Access Compliance Report

Public Rights-of-Way

(Curb Ramps)

Intersection ID: 28315	Main Street: CARMODY_CT	Cross Street: ZACKERY_AV	Location: NW
ADA ID: 9DC0C0FFE9D6	Ramp Type: BlendTrans1	Initial Pass/Fail: Pass	Overall Compliance: No
		Severity Score: 15

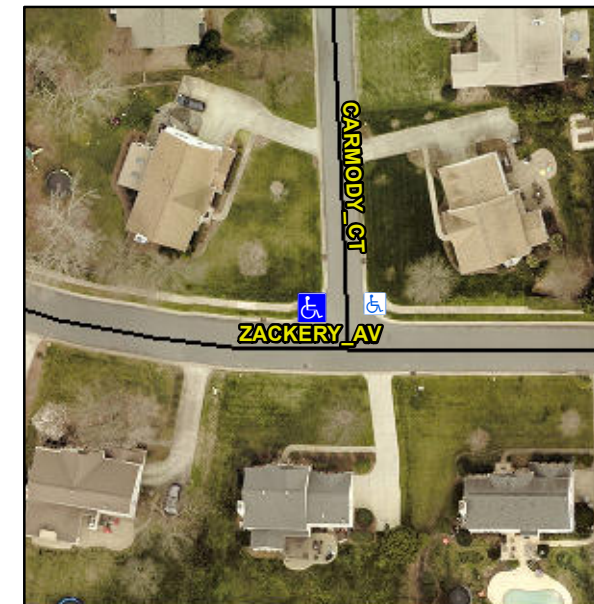
Not Found, R304.2.1, R304.2.2-Perp, R304.3.2-Para, R305, R304.5.4

N/A	Ramp inside XWalk1?	N/A	N/A	Ramp inside XWalk2?	N/A
	Road Slope (%)	0.2		Clear Space?	Yes
	Road X Slope (%)	4.2	N/A	Clear Space to XWalk (in)	N/A
Yes	Any Obstructions?	No	Yes	Storm Grate/Utility Hazard?	No
	Obstruction Type			Storm Grate/Utility Type	
		N/A			N/A
			Yes	Surface Condition? (G/P)	Good
			No	Curb Slope (%)	6.2

Remove & Replace Curb Ramp With Two New Directional Ramps or Equivalent. Remove & Replace Gutter.
